Addendum Number 1  
Document 00202

DOCUMENT 00202 - ADDENDUM NUMBER 1

Roof Replacement  
Bradley Park - ESC Paint Shop  
1314 N. Park Road  
Peoria, IL 61604

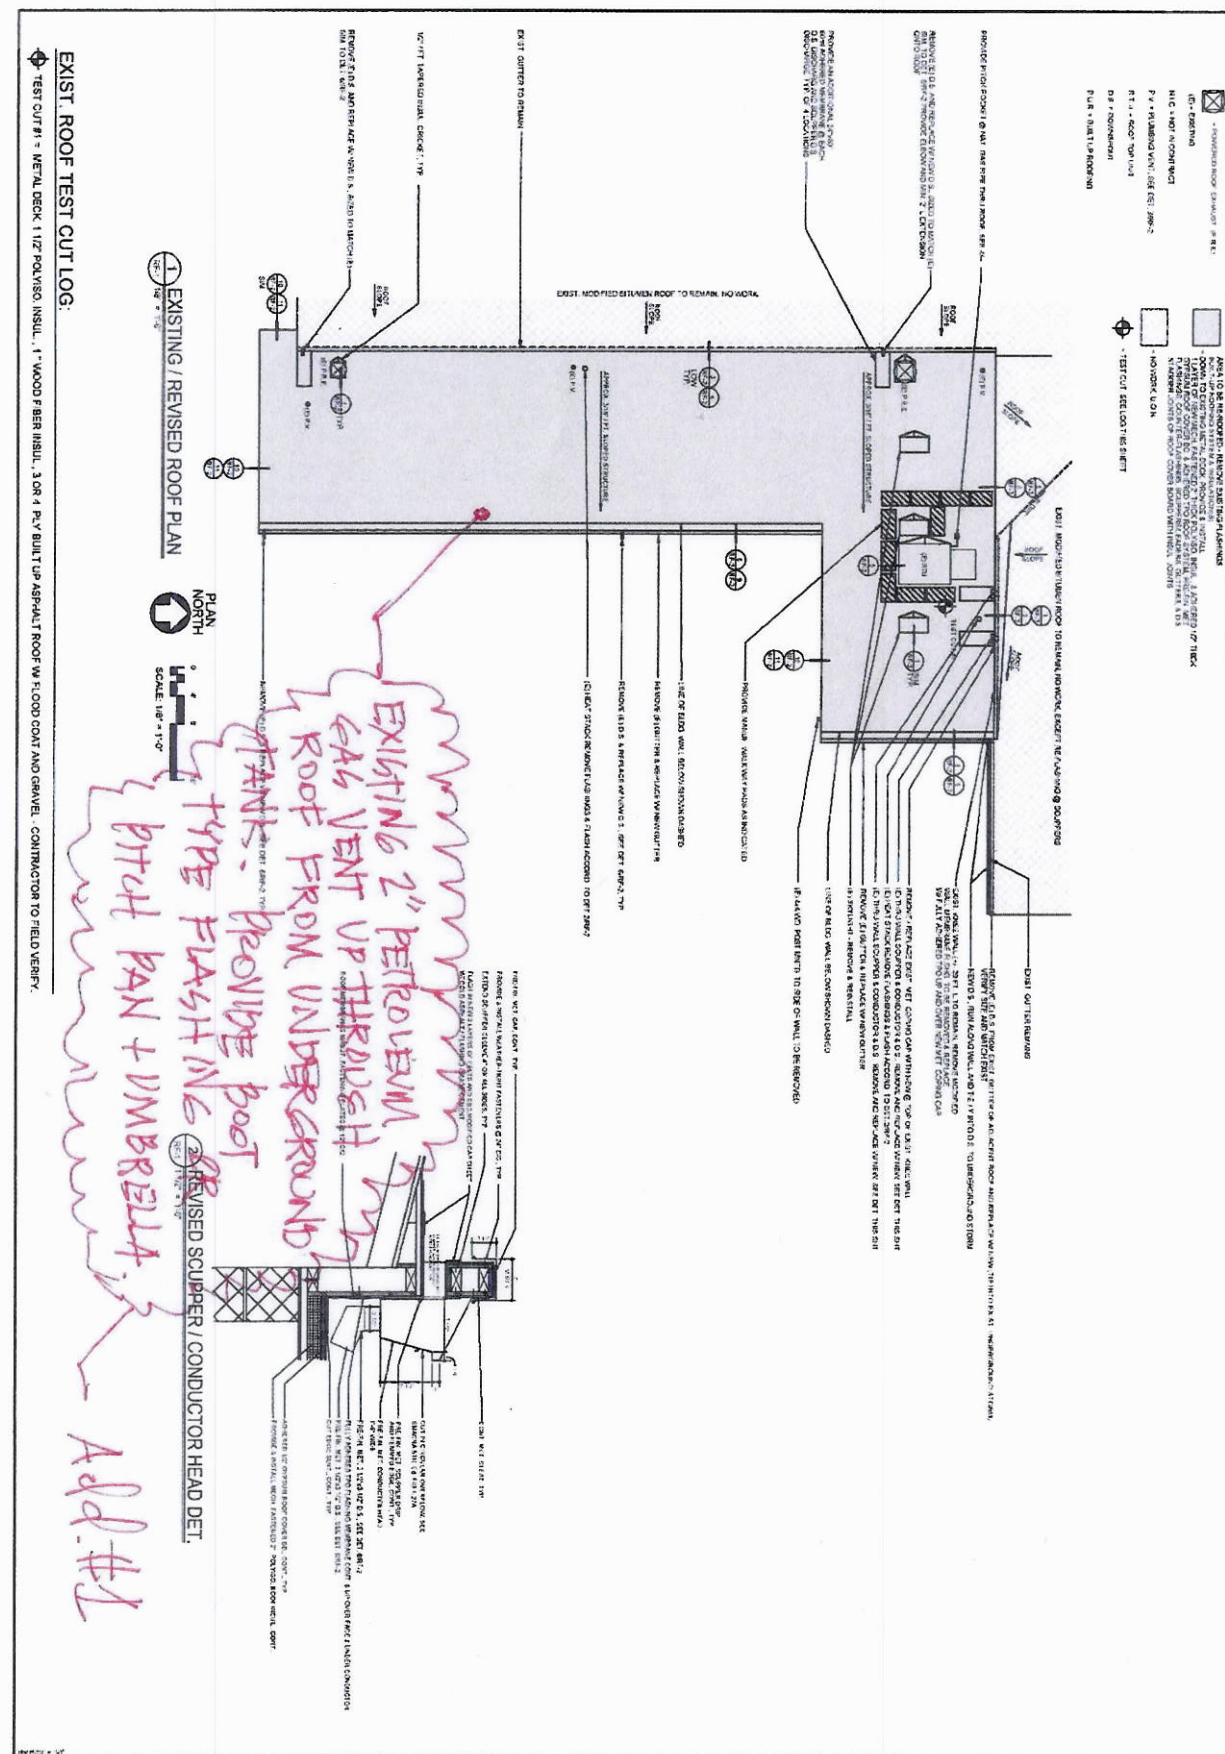
1. See the attached 8 1/2x11 roof plan with the existing petroleum vent to be added to the contract documents.
